July 2, 2012

Phillip O. Ellis
Strategic Analysis & Government Affairs
Public Service Commission
2540 Shumard Oak Boulevard
Tallahassee, FL 32399-0850
pellis@psc.state.fl.us

Re: Comments on Gulf Power's Ten-Year Plan Submittal

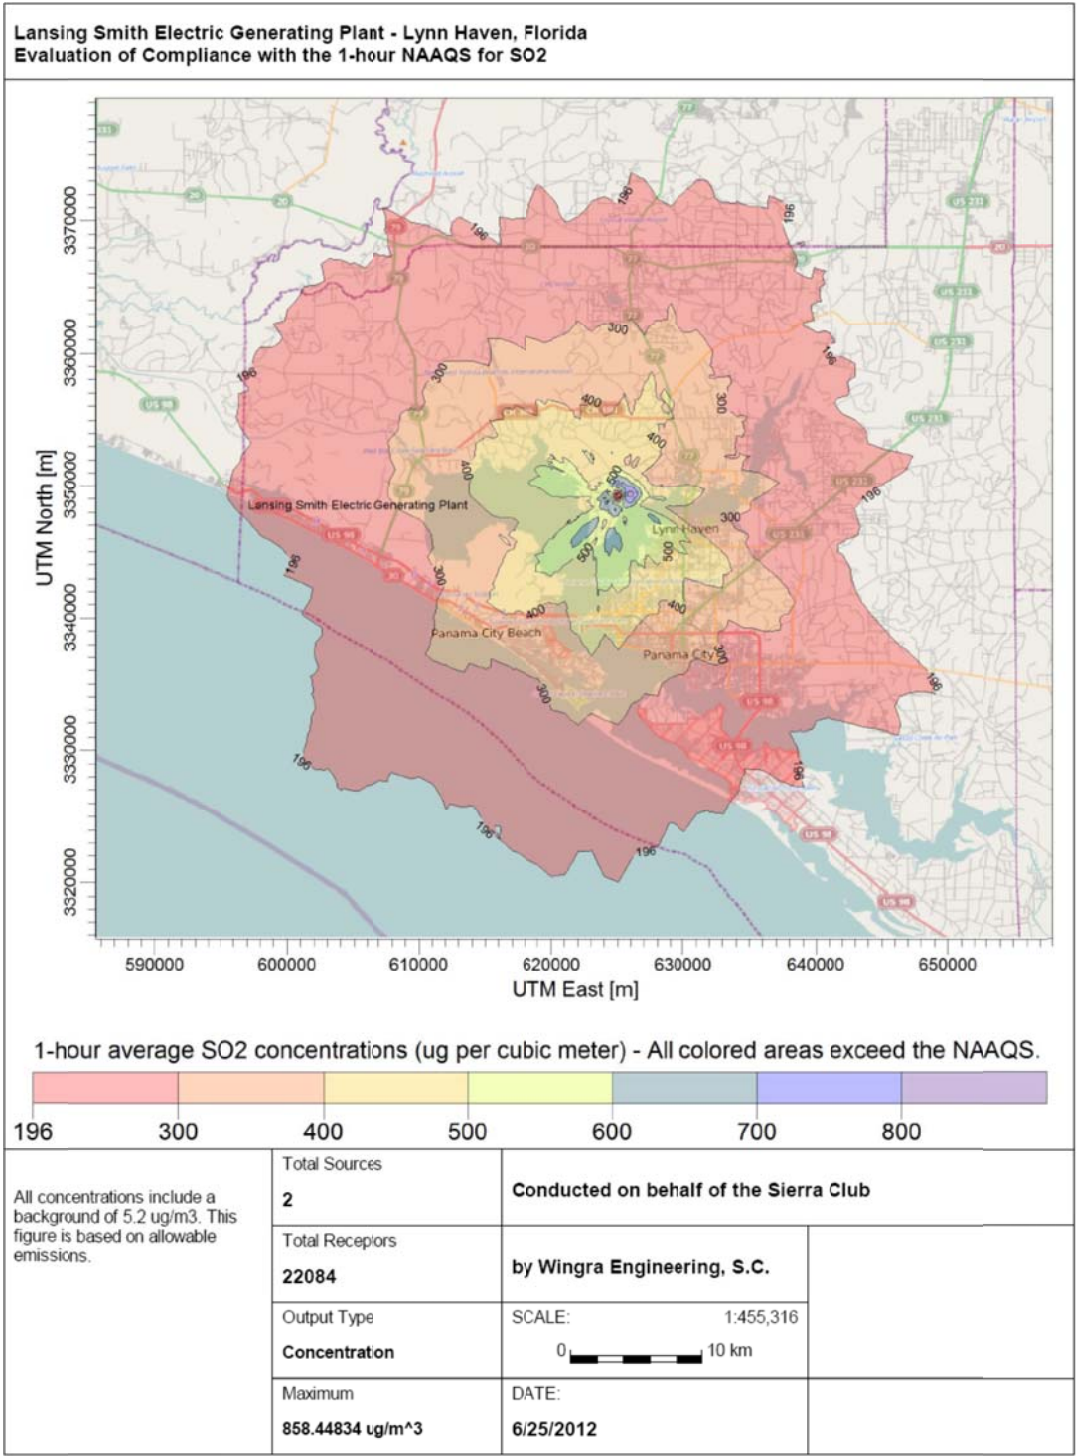
This tight timeline is directly relevant to the Commission’s review of Gulf Power’s plans because the Lansing Smith plant is causing violations of the NAAQS, and so will have to install controls under any legal SIP. Sierra Club engaged an expert air modeler, Steve Klafka of Wingra Engineering, to evaluate the plant’s compliance with the NAAQS, using EPA’s models and methodology.² We modeled both the plant’s allowable emissions – those authorized by its Title V Air Operation Permit, No. 0050014-018-AV – and its maximum emissions in 2011, the most recent year with complete data in EPA’s Air Pollution Markets Database. Whether measured by its permit or by its most recent maximum emissions, the plant causes the pollution in the air over Panama City to reach unsafe levels, violating the NAAQS several-fold.

The figure below shows the SO₂ pollution plume the plant would create when operating at its permit limits. All colored areas violate the NAAQS. While the NAAQS is set at 196.2 µg/m³, Lansing Smith's permit allows pollution levels to soar to 858.4 µg/m³, over 400% of the safe value; even a bit further away from the plant, pollution directly over downtown Panama City reaches levels close to double the safe value.

Importantly, Lansing Smith causes NAAQS violations even when operating below its permitted maximums. Last year, Lansing Smith's highest operating hour emissions saw SO₂ concentrations reach 346.5 µg/m³, which is nearly double the safe value. See Ex. 2 at Table 1.

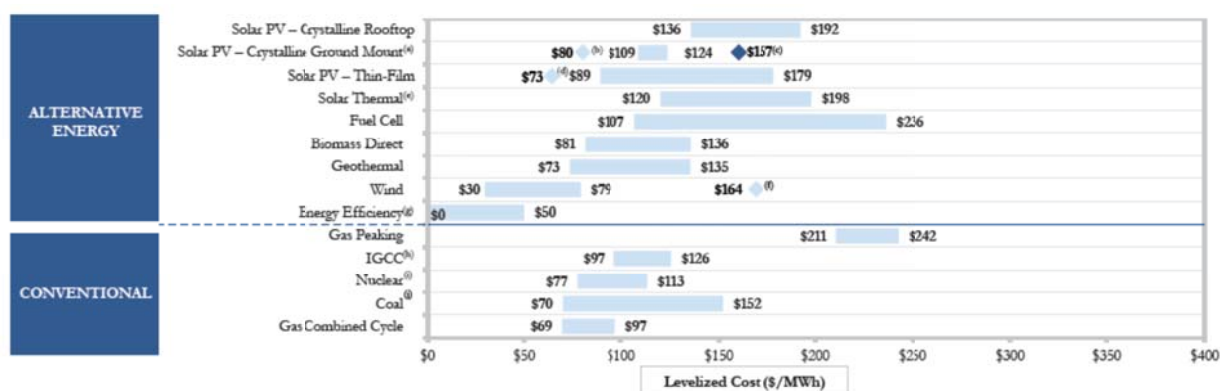
Industry-wide levelized cost figures compiled by independent analysts demonstrate why these retirements are occurring. The most recent (2011) edition of Lazard’s Levelized Cost of Energy Analysis,¹¹ a widely-used reference, shows that energy efficiency, wind, and natural gas combined cycle levelized costs are already below those of coal, as the figure below demonstrates.
